# REGIONAL REVIEW NOTIFICATION

**Name of Proposal:** Mt. Zion & Richardson (DRI #3039)

**Description:** A Development of Regional Impact (DRI) review of a proposed project to build two distribution warehouses on a 70.2-acre site in unincorporated Clayton County at 2464 Mt. Zion Road near the intersection with Richardson Parkway. The site is near the Interstate 75 interchange at Mt. Zion Boulevard. The project proposes one warehouse of 412,300 SF and the other 474,300 SF. Access will be provided with two new driveways on Richardson Parkway. The location is served by MARTA route #194. The local trigger is a rezoning. Expected buildout is 2022.

**CONCEPT SITE PLAN**  
 2464 MT. ZION ROAD TRACT  
 PROJECT LOCATED AT:  
 LL 84 AND 85, 12TH DISTRICT  
 CLAYTON COUNTY, GEORGIA

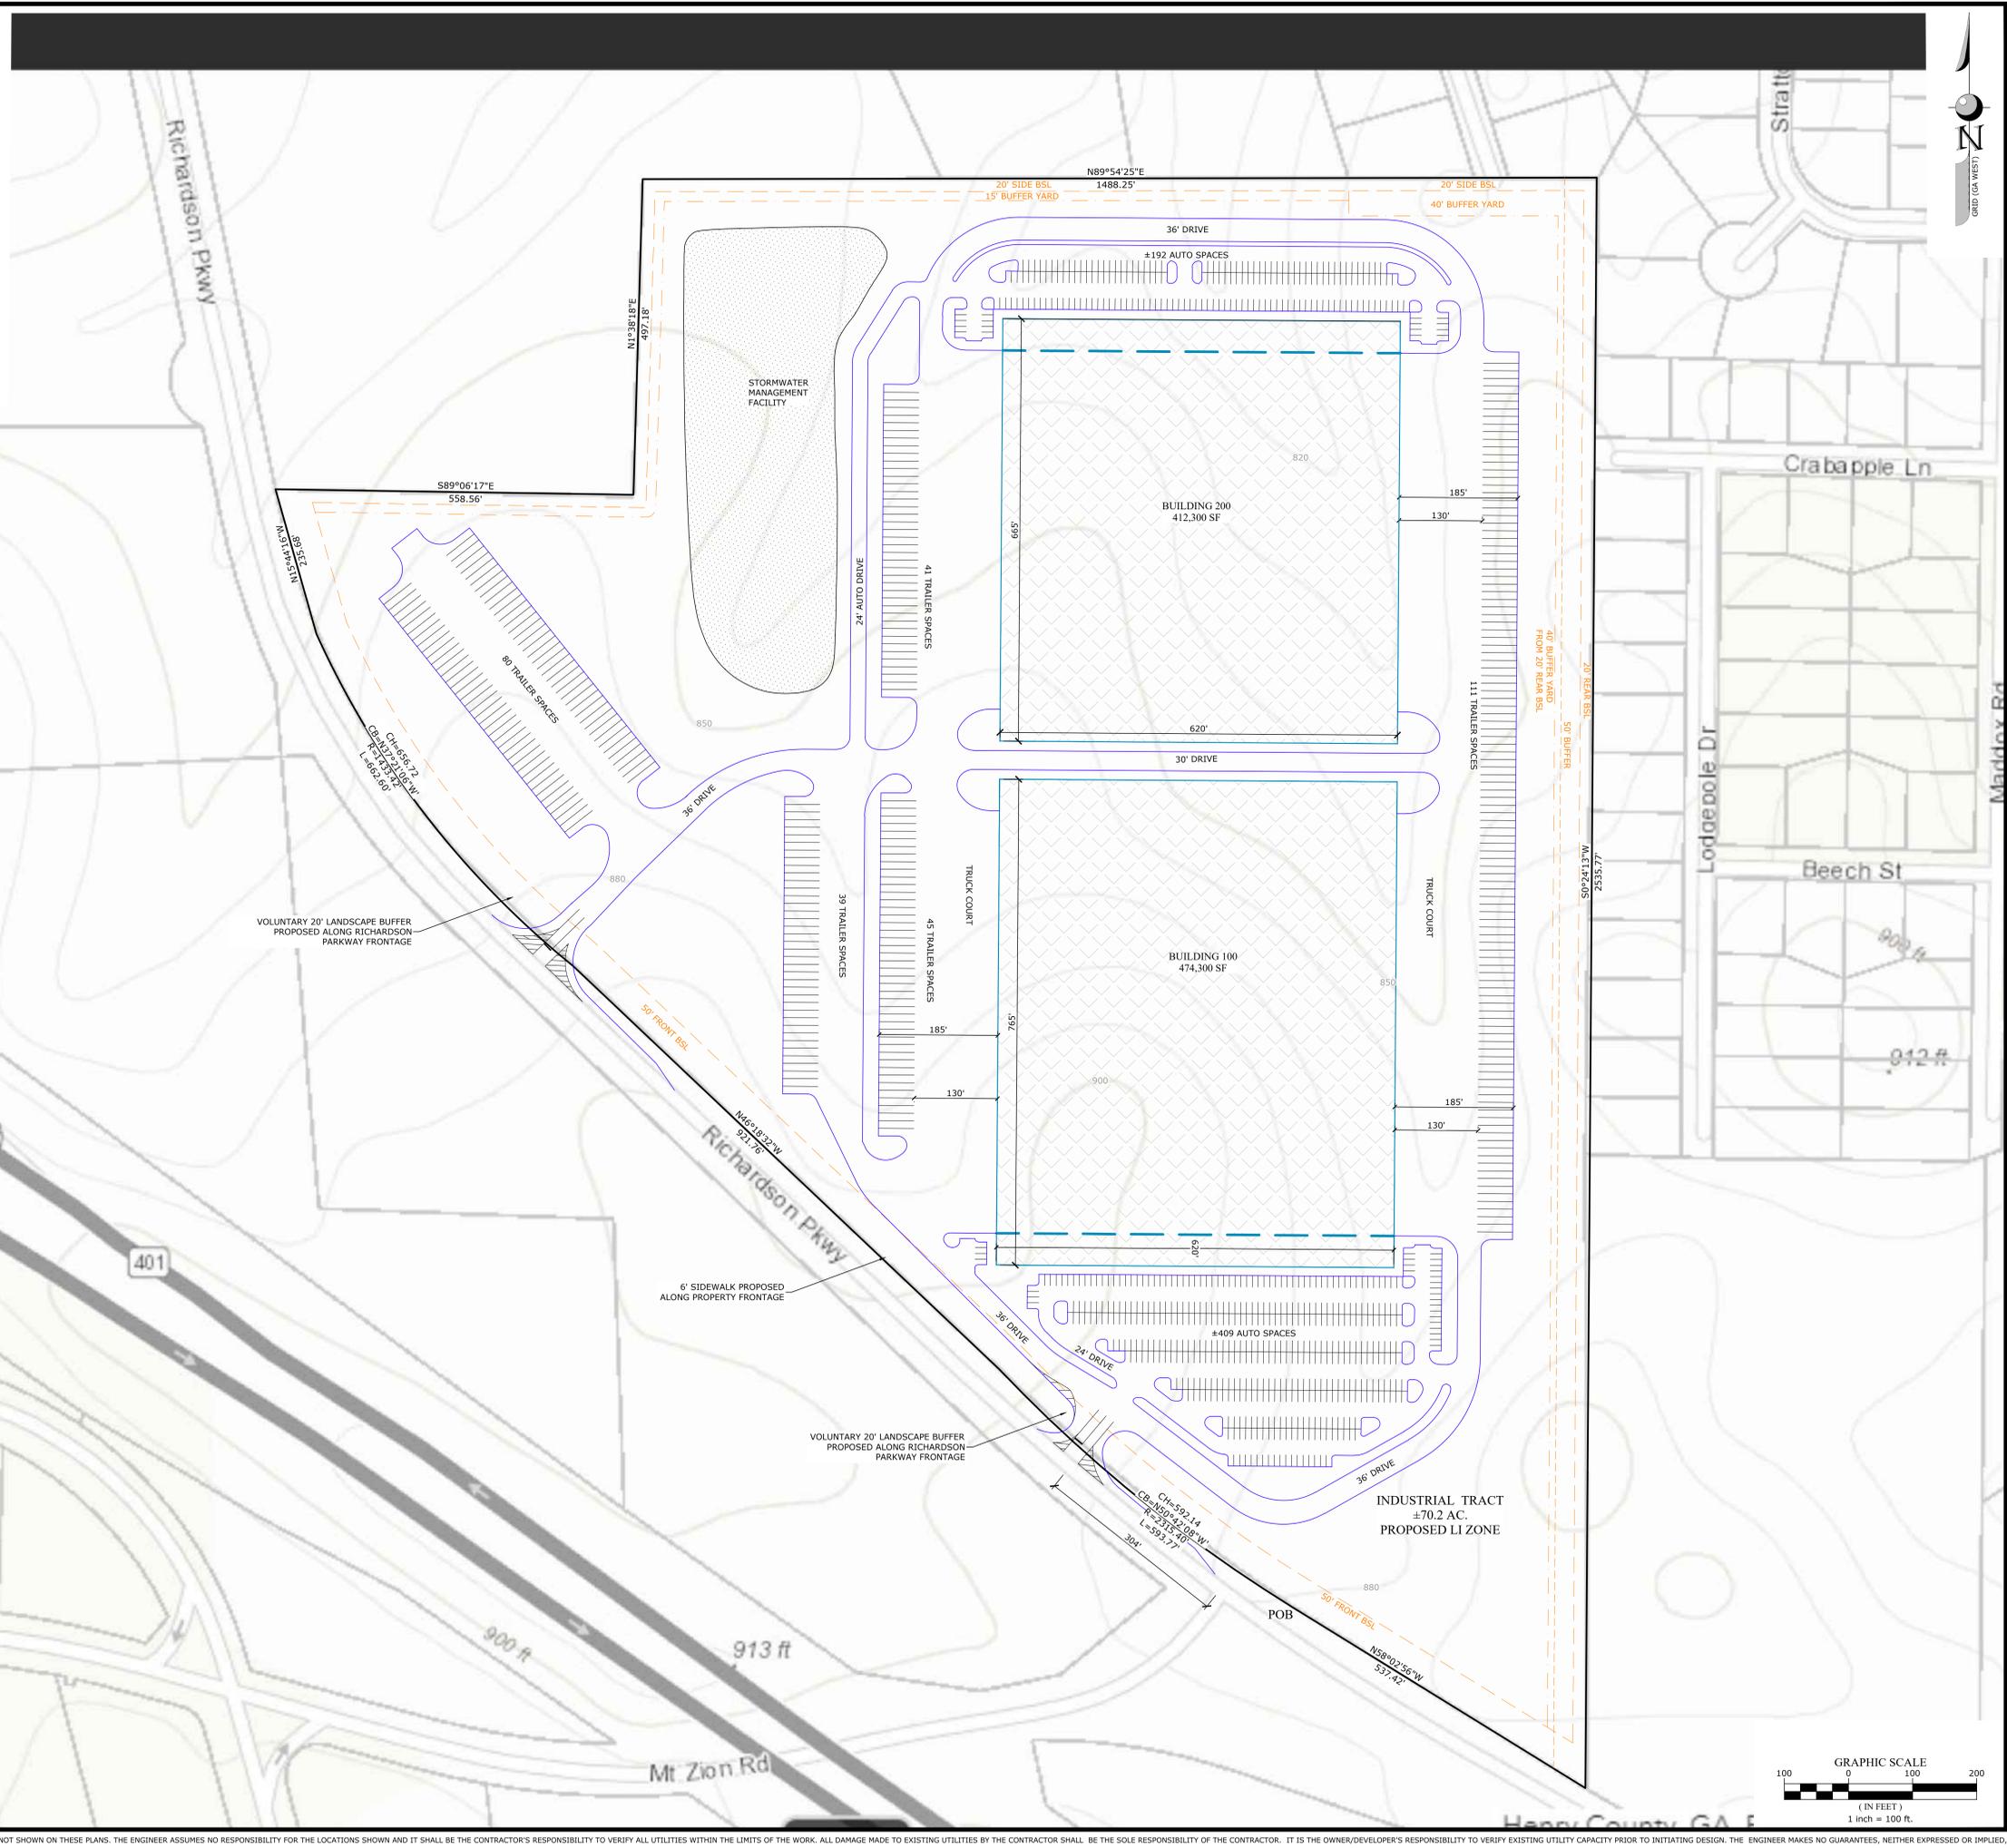
Pedestrian facilities do not exist along Richardson Parkway and appear incomplete along Mount Zion Parkway adjacent to the development. Bicycle facilities do not exist along either roadway.

Truck and vehicular traffic share access points and drive aisles.

It is recommended that sidewalk connections be completed along the Mount Zion Parkway and along Richardson Parkway adjacent to the development.

The USGS coverage for the project area shows no blue-line streams on or near the property. Any unmapped streams on the property may be subject to the Clayton County Stream Buffer Ordinance as well as the State 25-foot State Erosion and Sedimentation Act buffer are shown on all the streams. Any unmapped waters of the state may also be subject to the State erosion and sedimentation buffer.
